Subject: Acoustic I-Audit for the Cedar Point II Wind Power Project  
REA#6914-95L5JBB

This letter contains responses to MECP comments received on July 9, 2019 for the Cedar Point II Wind Power Project I-audit reports which are provided below. Original MECP comment is provided in black and Aercoustics’ response is provided in purple.

Figure 1 M1414 - 2nd Immission Audit - Turbine ON and Background

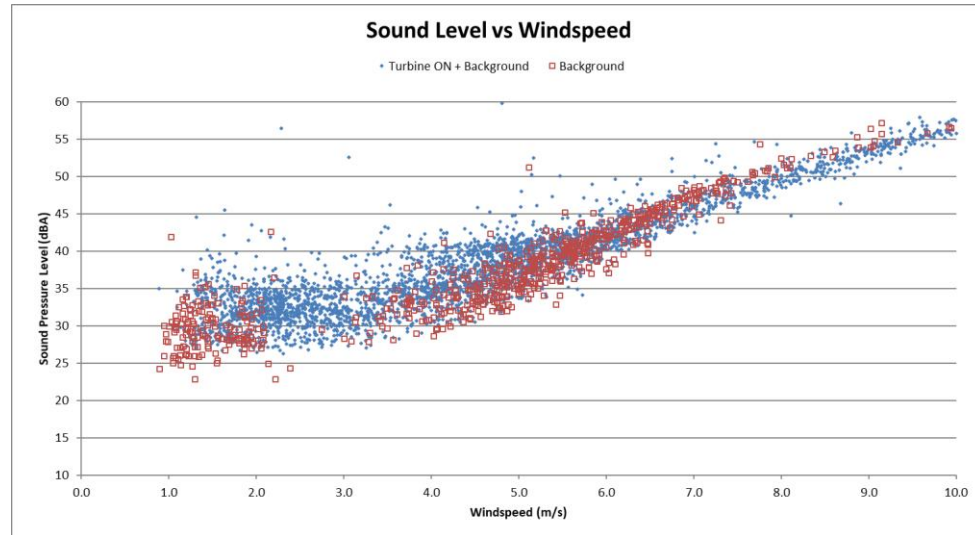
- M1414 Fall Audit, OFF status, Dec. 1, 2016, 10:31:00 PM, sound level at 5.1 m/s wind speed recorded as 51.2 dBA (exclude data point at same night at 5.8 m/s wind speed recorded as 41.9 dBA, about 10 dB lower than the number in the calculations). This is an invalid data point.
- M1414 Fall Audit, OFF status, Dec. 20, 2016, 4:19 AM: sound level at 7.4 m/s wind speed recorded as 49.8 dBA. This is greater than 95% of the all data collected for the same bin at the same receptor (420 data points were collected in total for Turbine ON, Turbine OFF measurements as well as the acceptable excluded number of data points). It is unclear what source(s) would cause a sound level of 49.8 dBA at 4am. This makes the analysis unacceptable.

The scatter plot of sound level vs wind speed for M1414 Fall audit is provided in Figure 1.

It can be seen that although outliers are included in the data, that there is little contamination in the Background data spread. There is one outlier in the background dataset which corresponds to the data point highlighted by the Ministry (M1414 Fall audit, OFF Status, Dec 1, 2016 10:31 pm – 5.1m/s and 51.2 dBA). The inclusion of this contaminated data point is considered negligible and does not affect the assessment of compliance.

The data point has been removed from the analysis and the results presented in Appendix A. The removal of the contaminated data point resulted in a 0.5 dB reduction to the background sound level in the 5m/s wind bin. Compliance is demonstrated after the removal of the contaminated data point. Furthermore, the maximum Turbine Only level in any wind bin for this monitor has a margin of compliance of 3dBA. It is unlikely that removing additional outliers would change the compliance status at this monitoring location.

Figure 2: Example of the typical relationship between sound level and wind speed for Turbine ON and Background periods

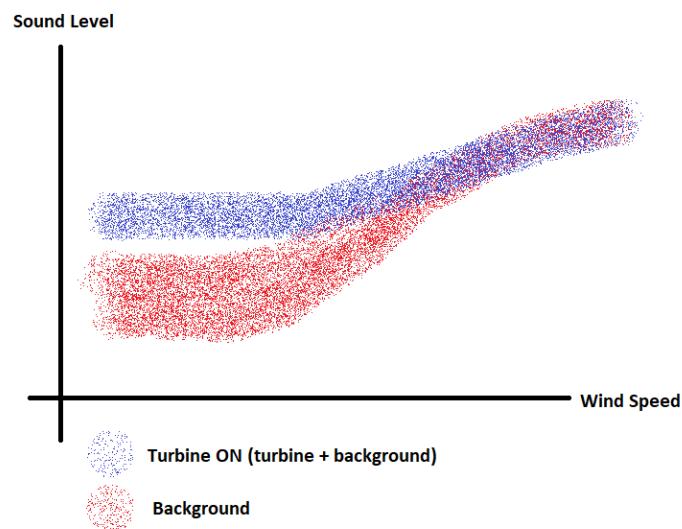
**2 – Trend of Data (reference to Table 4-9 of the audit reports):** The trend of equivalent sound levels (Leq) for wind turbine ON status from one consecutive wind speed bin to the next is different from the equivalent sound levels (Leq) for wind turbine OFF status. Note that, the number of data points for collected Turbine ON status is also significantly higher than the number of data points collected for Turbine OFF status (for example, for the M96 Spring Audit for a wind speed 5 m/s, the number of ON data points is approximately three times greater than the number of OFF data points (1077 to 372 respectively), making the trend of the sound levels for Leq OFF more inaccurately impactful than the Leq ON. The selection and trend of the OFF data points were performed in a way that makes the assessment unacceptable as the changes in the Leq OFF are significantly higher than the Leq ON. For reference, a couple of example are shown below:

- M96 – Spring Audit: Observing the change from bin 5m/s to 6m/s, the difference in the Leq OFF is 4.7 dB (=42.3 -37.6) as opposed to the difference in the Leq ON of 2.7 dB (=44.1 -41.4)
- M1414 Fall Audit: Observing the change from bin 5 m/s to 6 m/s, the difference in the Leq OFF is 4.2 dB (= 42 – 37.8) as opposed to the difference in Leq ON of 2.1 dB (= 42.4 – 40.4). This trend is not representative of the data of this monitoring location as the slope of the Turbine OFF data is twice as great as the slope of the Turbine ON data when plotting the data on a graph depicting sound levels against wind speed bins. This makes the submitted analysis unacceptable.
- M1414 Fall Audit: The Leq OFF is 46.9 dBA and is greater than the Leq ON of 46.7 dBA for a wind speed bin of 7 m/s. This makes the analysis unacceptable.

Trend analysis of wind turbine levels sound levels should be approached with caution because the relationship between ground level winds and wind-induced ambient noise is not linear, it's logarithmic [1] [2] [3]. Further, the trend of the Turbine ON levels vs. ground level wind speed has two distinct sections: at low ground level winds where the turbine noise dominates, and at high ground level

winds where the ambient noise dominates. The typical relationship between wind speed and sound level of both ambient and Turbine ON sound levels is shown in the conceptual drawing in Figure 1. The wind speed at which the ambient noise overtakes Turbine ON noise, the rate of increase of ambient noise, and the minimum sound level of ambient noise all depend on the nature of the surroundings for each monitor.

Trend analysis will also lead to increased error in the estimation of turbine sound levels if the correlation coefficient of the data is low. For example, the IEC 61400-11 (edition 2.1) standard requires a minimum coefficient before trend analysis can be conducted; it also uses a 4<sup>th</sup> order polynomial fit to the data. Further, the subsequent revision of the IEC standard (Edition 3.0) abandoned trend analysis altogether in favour of the binning method (which is the same method used by the Compliance Protocol). Receptor-based field measurements experience more variation in measured sound level compared to IEC 61400-11 measurements, which therefore makes trend analysis even more prone to error.
